File: A018/21

Address: 22 Dianawood Ridge, Woodbridge

Staff Report Prepared By: Lenore Providence
Hearing Date: Thursday, March 18, 2021

Minor Variance Application

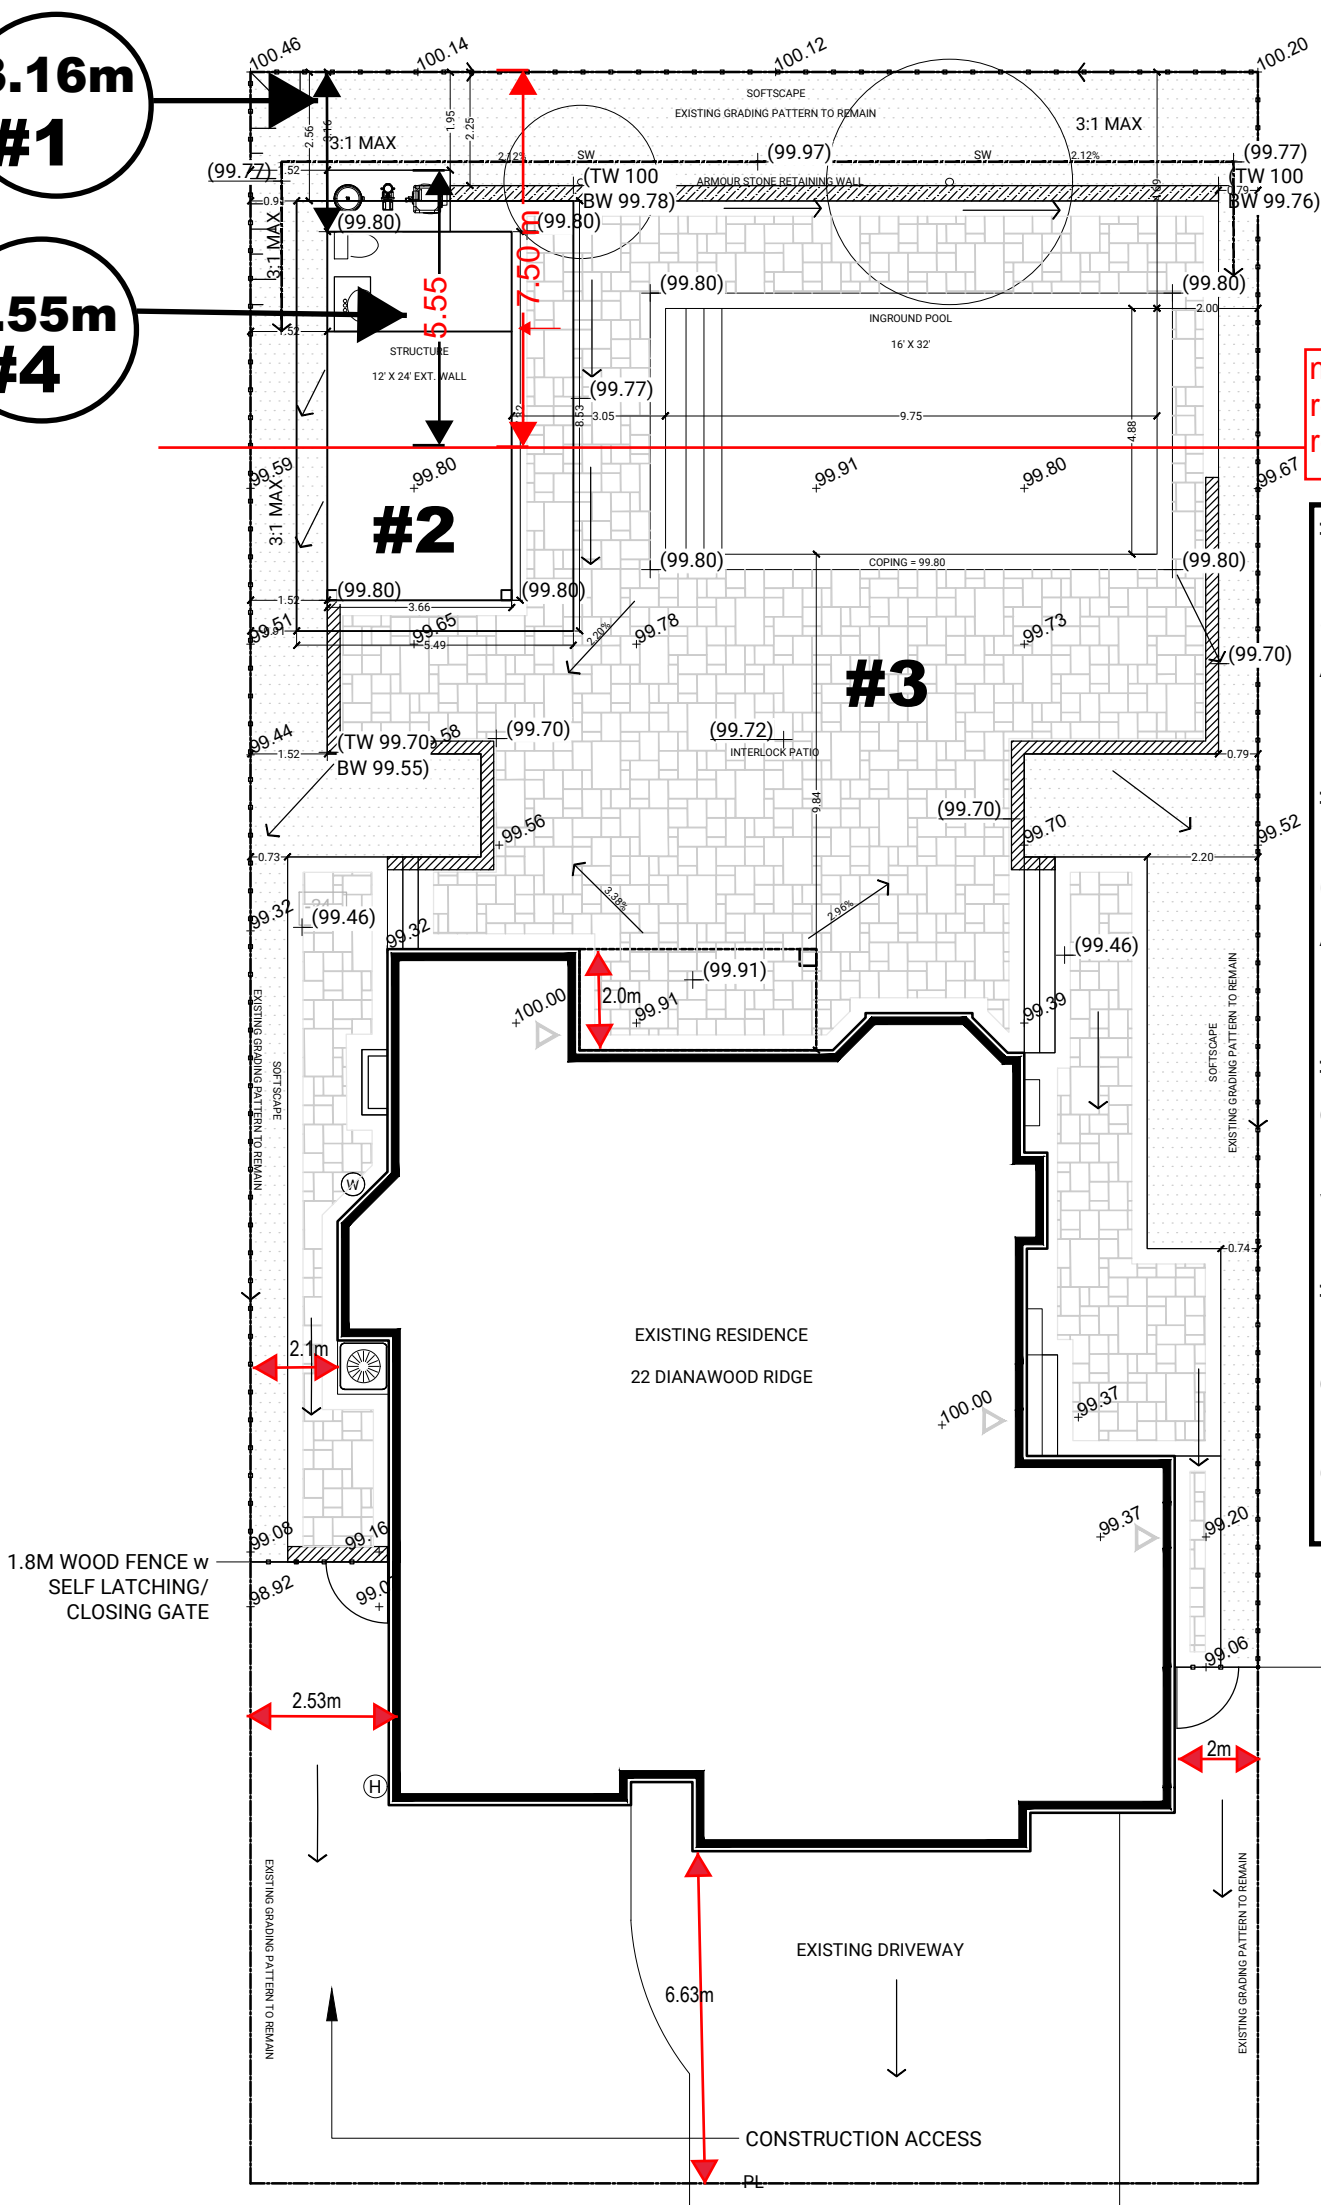
3.16m
#1

5.55m
#4

#1 To permit a minimum Rear Yard setback of 3.16 metres to an Accessory Structure (Cabana).

#2 To permit a maximum Eave encroachment of 0.61 metres for an Accessory Structure (Cabana).

#3 To permit a minimum of 41.57% of Soft Landscaping in the rear yard.

#4 To permit a maximum Rear yard Encroachment of 5.55 metres for Ground mounted pool equipment.
